17 October 2018

170514-1

**GEOTECHNICAL RESPONSE TO REQUESTS FOR ADDITIONAL INFORMATION
PROPOSED WINDFARM - ROTOKOHU ROAD, PAEROA
APPLICATION NO: APP139668**

SITE: KAIMAI WIND FARM
 ROTOKOHU ROAD, PAEROA
TITLE: PRELIMINARY CIVIL ENGINEERING
 DRAWINGS
SUBTITLE: PROPOSED CLEAN-FILL OVERVIEW

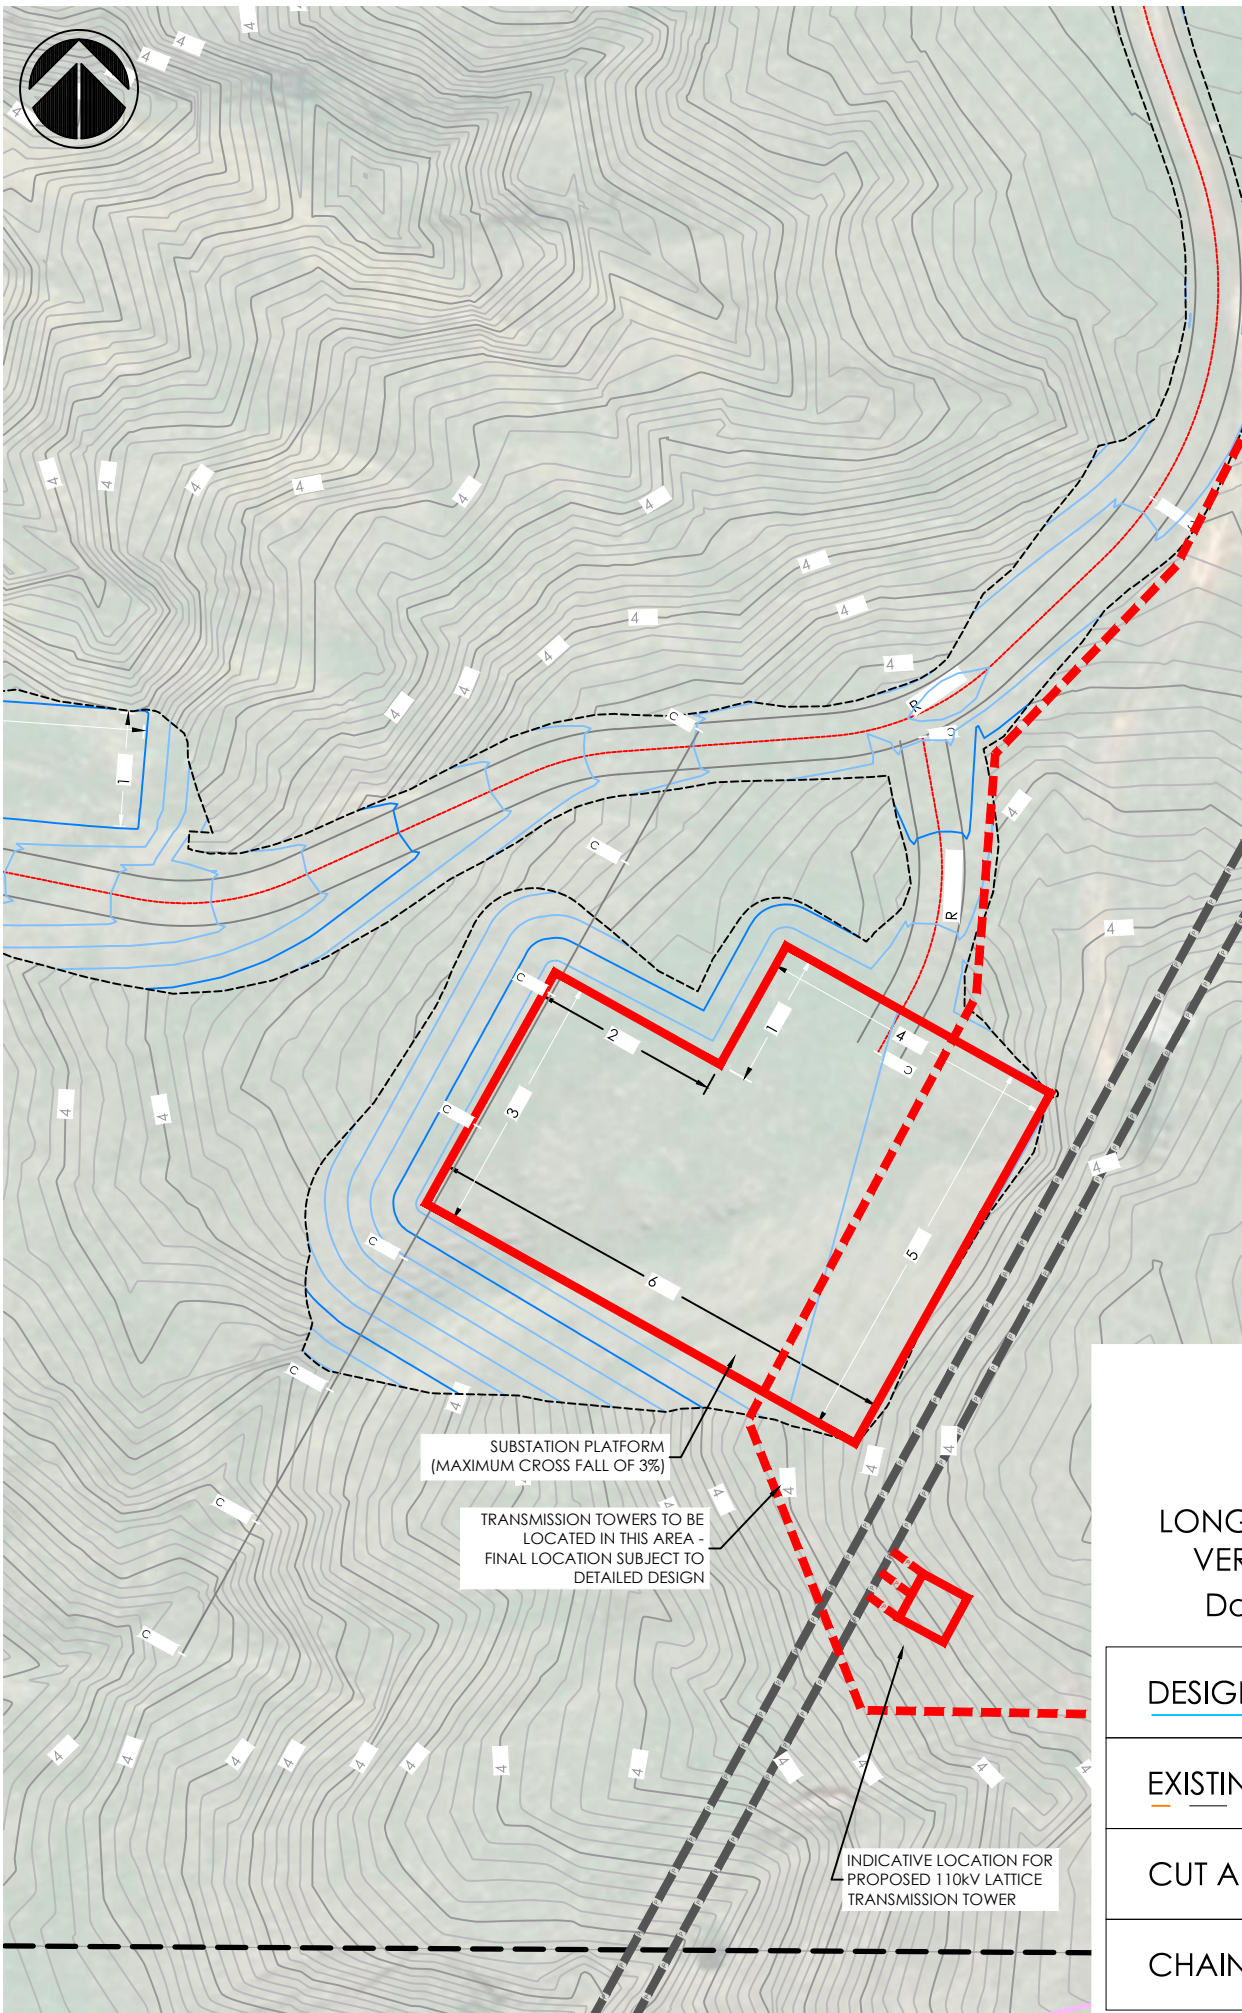
We have been provided with plans showing proposed clean fill areas, prepared by Tektus, attached. We understand that there are many potential clean fill areas proposed and the areas are located across different parts of the site to minimise tracking of material and minimise the overall size of the clean fills.

The clean fills that have been analysed are annotated on the Site Plan provided by Tektus (attached) and the existing and finished ground profile of the clean fills are shown on the attached Cross Sections. The ground profile and groundwater levels have been assumed based on subsurface information from the general area surrounding the clean fill site.

We have been provided with four representative clean fill sites from Tektus which have been assessed for long term stability. The maximum depth of fill is approximately 10m for proposed clean fill 1, with the steepest front face grade of 1 vertical on 4 horizontal at proposed clean fill 2.

Factor of Safety		
	Estimated Groundwater	Raised Groundwater	Seismic
Required by Council	1.5	1.3	1.0
Clean Fill Site 1	4.0	3.1	1.1
Clean Fill Site 2	2.4	1.9	1.0
Clean Fill Site 3	2.7	2.3	1.1
Clean Fill Site 4	3.9	2.7	1.3

SUBTITLE: PROPOSED SUBSTATION PLATFORM

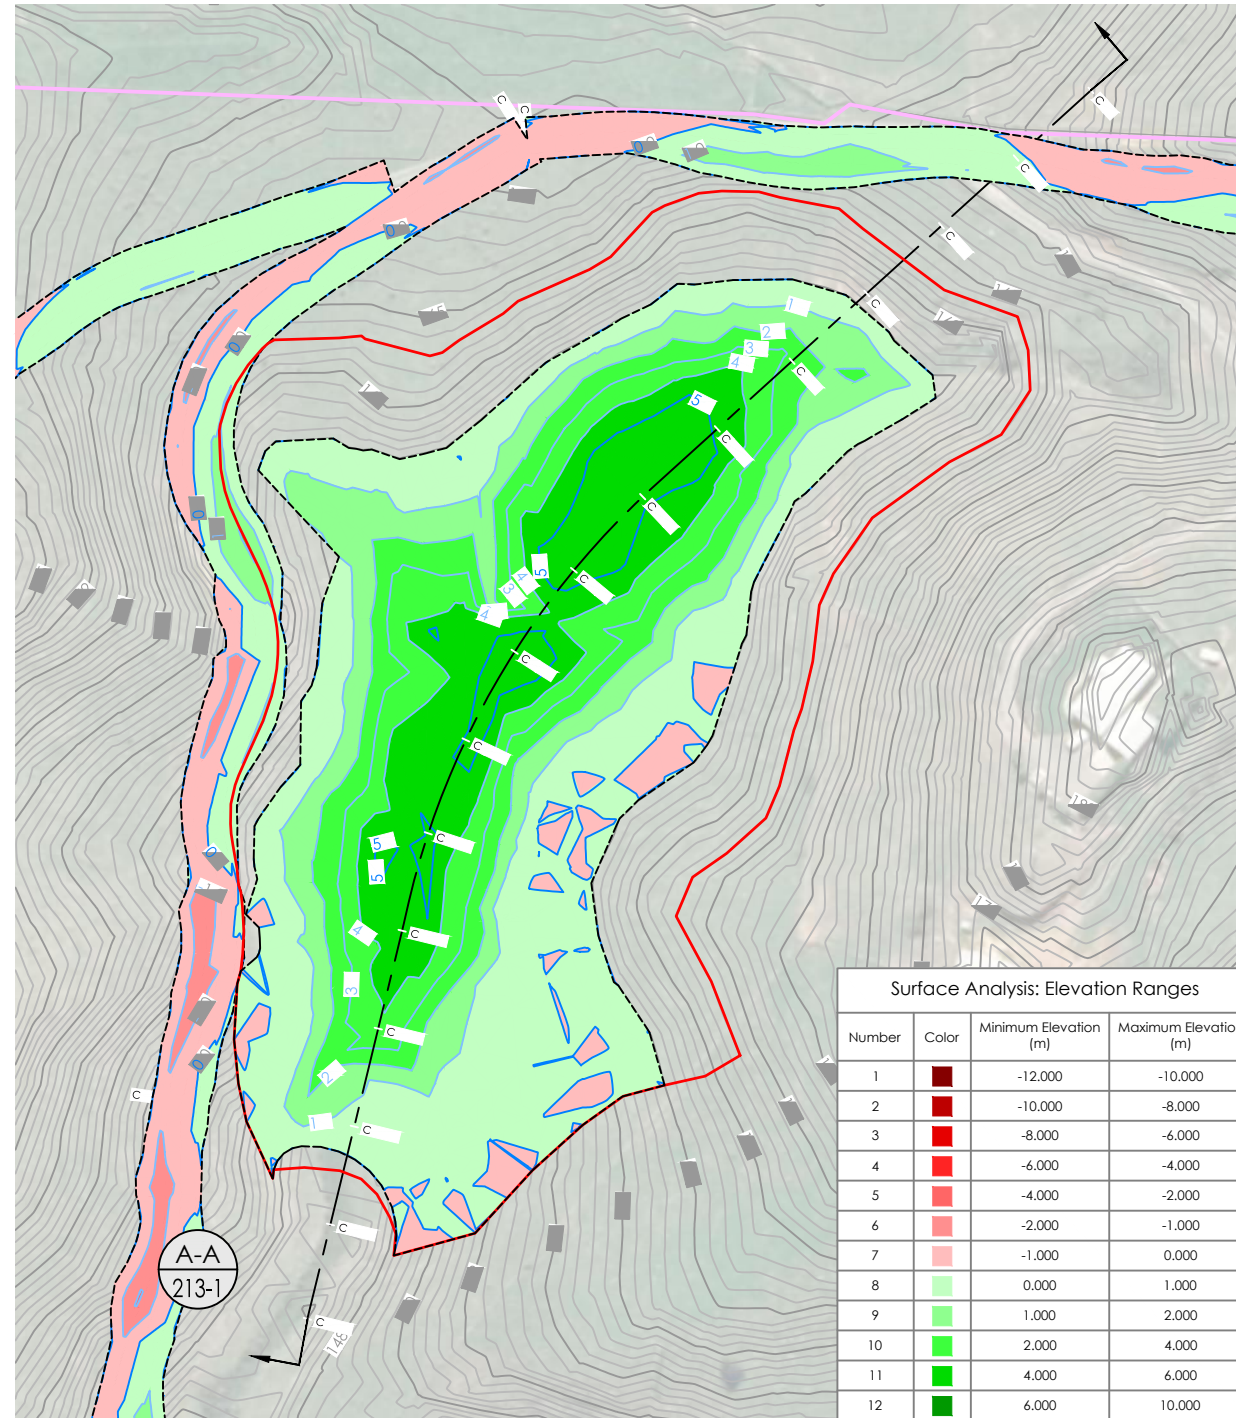
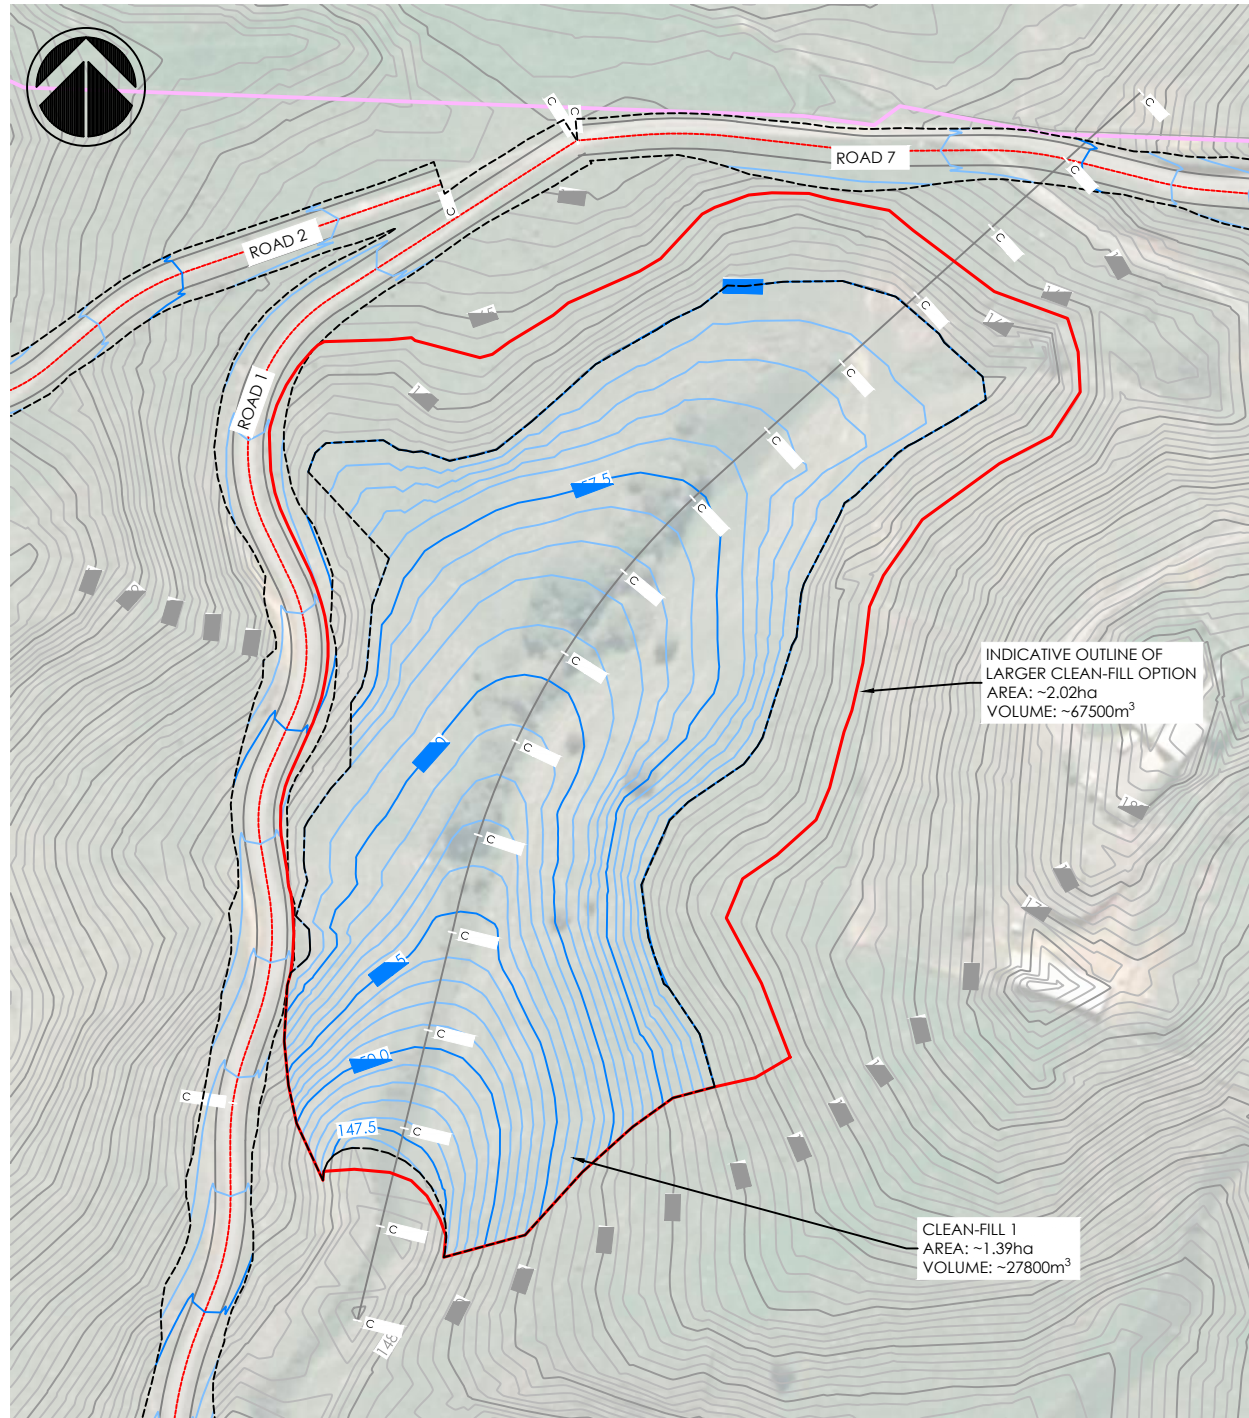
Item 5 Point 6 - Substation

The proposed substation is to be constructed on a raised fill platform. The fill is locally up to approximately 11m thick and is to grade into the existing ground surface at grades of between 1 vertical on 1 horizontal and 1 vertical on 2 horizontal. The proposed batter grades are too steep to stand unsupported and we recommend that the batter slopes be formed as reinforced soil slopes.

Stability analyses show that under static conditions, an acceptable factor of safety could be met with reinforcing over the front face only.

However, an acceptable factor of safety could not be met under seismic conditions. The reinforcing was extended across the entire width of the fill platform at 0.5m spacing and an acceptable factor of safety was achieved. The seismic analyses have been undertaken based on a horizontal seismic coefficient of 0.37g, calculated in accordance with the Earthquake Geotechnical Engineering Practice Module 1, with reference to NZS1170.0:2002 and NZS1170.5:2004. The substation is considered as an Importance Level 3 (IL3) structure.

Based on our analysis, we therefore recommend that the entire substation fill platform is constructed as a reinforced earth embankment. Printouts of the stability analyses are appended.
